Subject: Response to U.S. EPR Design Certification Application RAI No. 390, FSAR Ch. 9, Supplement 13
Sent Date: 5/5/2011 4:36:49 PM
Received Date: 5/5/2011 4:42:06 PM
From: WELLS Russell (AREVA)

Request for Additional Information No. 390 (4614, 4620, 4616), Supplement 13

U.S. EPR Standard Design Certification

**SRP Section: 09.05.04 - Emergency Diesel Engine Fuel Oil Storage and Transfer
System**

Figure 2.5.4-1—Emergency Diesel Generator Fuel Oil Storage and Transfer System Functional Arrangement
Sheet 1 of 4

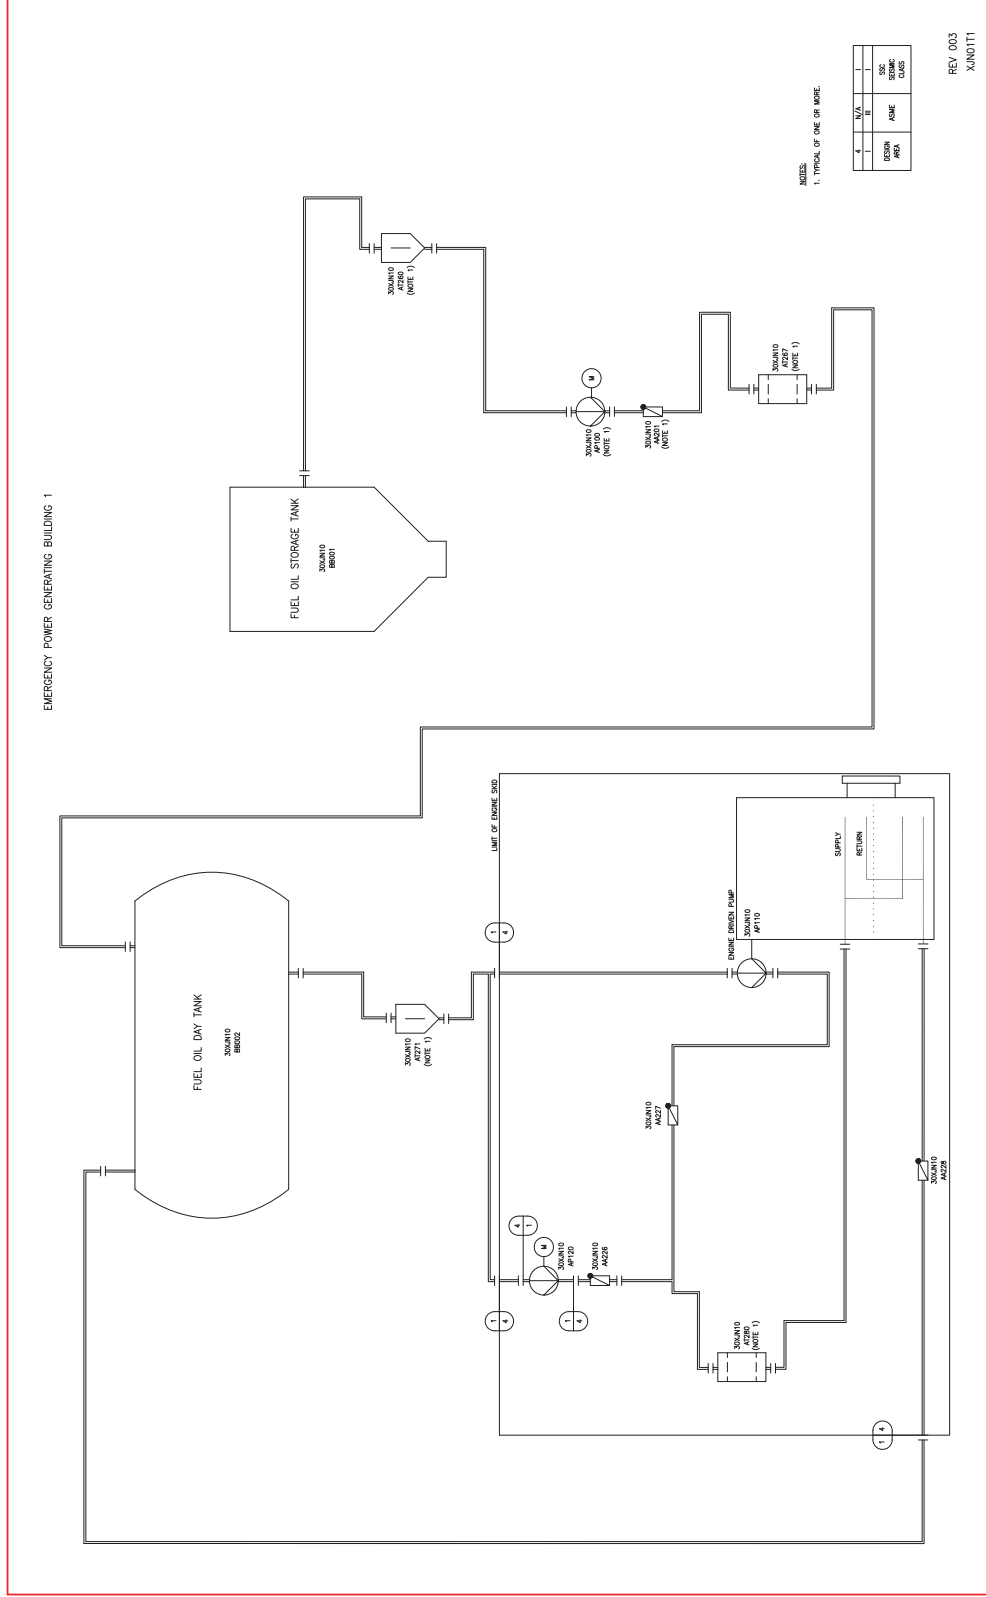
Question 09.05.04-24:**Follow-up to RAI 152, Question 09.05.04-15**

Tier 1 Table 2.5.4-1 includes a column to indicate the required function of each of the system components listed. However, the function descriptions added for FSAR Revision 1 are too general to serve any purpose. For example, the function of the fuel oil storage tanks is indicated as "Storage Volume". The tank's function is to store a 7-day supply of oil volume and that should be included in the description of the function. Another example is the function indicated for the fuel oil transfer pumps which is "Run". The specific function is to run and supply oil at the required flow rate and pressure for continuous EDG operation at rated conditions. A final example is that of the check valves whose function is listed as "Open, Close". A check valve's function is to allow flow in only one direction through the system. These are some examples – the entire list should be revised as appropriate to more specifically describe the required functions of the components. As an alternative, the column could be deleted since the function of most components is apparent from the name of the component and/or the description in the FSAR text. If the column is deleted, Tier 1, Section 2.5.4, Subsection 3.13 and Subsection 9.5 of the FSAR would have to be revised accordingly. Note that this RAI is applicable to all of the EDG support systems as described in FSAR Sections 9.5.4 through 9.5.8. The RAI will not be repeated for each section of the FSAR and the resolution will be tracked against Section 9.5.4 only.

During a review of U.S. EPR FSAR Tier 1, Table 2.5.4-1—Emergency Diesel Generator Equipment Mechanical Design, components were identified in this table that were present for seismic interaction considerations. U.S. EPR FSAR Tier 1, Section 3.9, “Seismic Subsystem Interaction” was previously added to the U.S. EPR FSAR as part of the response to RAI 370, Supplement 4, Question 03.07.03-38. U.S. EPR FSAR Tier 1, Section 3.9 requires a seismic interaction analysis summary, which concludes that non-Seismic Category I subsystems located within a potential impact zone of a Seismic Category I subsystem, will not impair the ability of Seismic Category I subsystems to perform their intended safety function. U.S. EPR FSAR Tier 1, Section 2.5.4 will be revised to remove references to Seismic Category II components, which are addressed in U.S. EPR FSAR Tier 1, Section 3.9.

U.S. EPR FSAR Tier 1, Section 2.5.4 will also be revised to resolve inconsistencies between U.S. EPR FSAR Tier 1 and Tier 2 in the areas of credited safety function, classification information (e.g., safety, seismic and ASME), and design information shown on the functional arrangement drawings of EDG support systems.

- Table 2.5.4-1—Emergency Diesel Generator Equipment Mechanical Design.
- Figure 2.5.4-1—Emergency Diesel Generator Fuel Oil Storage and Transfer System Functional Arrangement.
- Figure 2.5.4-2—Emergency Diesel Generator Lubricating Oil System Functional Arrangement.
- Figure 2.5.4-3—Emergency Diesel Generator Air Intake and Exhaust System Functional Arrangement.
- Figure 2.5.4-4—Emergency Diesel Generator Cooling Water System Functional Arrangement.
- Figure 2.5.4-5—Emergency Diesel Generator Starting Air System Functional Arrangement.

09.05.04-24
